Implementors Issue Log

Updated June 20, 2000

1 - Normal Mapping of two right-handed Shapes using CDSR

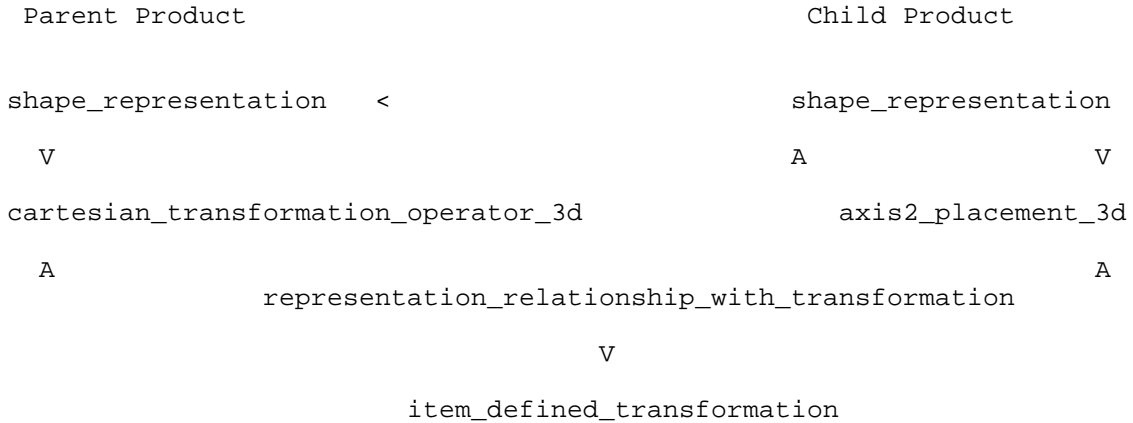
This is the Method normally used to position a Child with respect to a location within the Parent. Note that MAPPED_ITEM could also be used, but as we are dealing with Solids, and that CARTESIAN_TRANSFORM_OPERATOR_3D (CTO3D) is not allowed as one of the items within an ADVANCED_BREP_SHAPE_REPRESENTATION, we will not investigate this method.

2 - Mirroring via CDSR (NB - transformation can be at Parent ONLY)

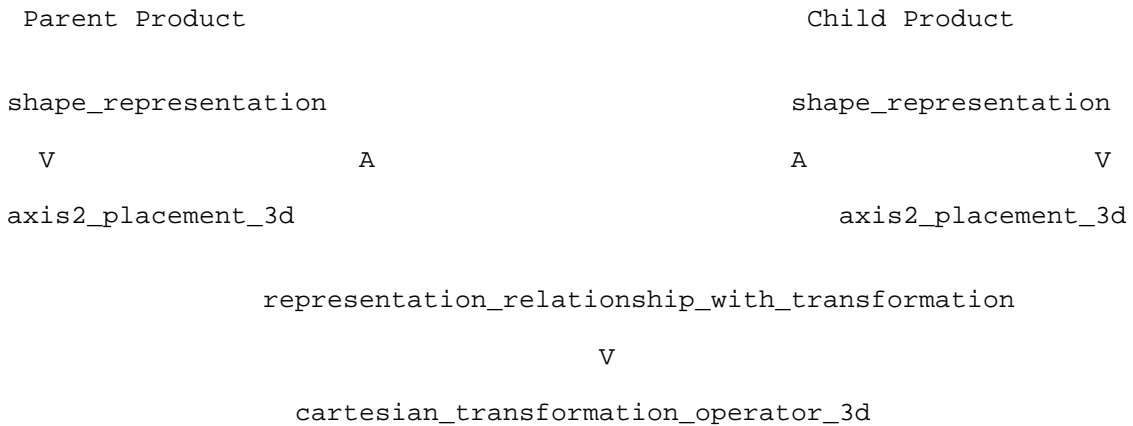
It has finally sunk in what Jeff Hunsaker from UG was trying to tell us at the last telecon. Originally, it was assumed that the CTO3D could be referenced by either the parent or the child, but since the child is always instantiated as a SUBTYPE of SHAPE_REPRESENTATION, then it cannot have the CTO3D in its set of Items, thus the CTO3D must always be part of the set associated with the Parent. Note that this will only work if the Parent node is a plain SHAPE_REPRESENTATION, i.e it has no Geometry associated with it that is not inherited via a relationship.
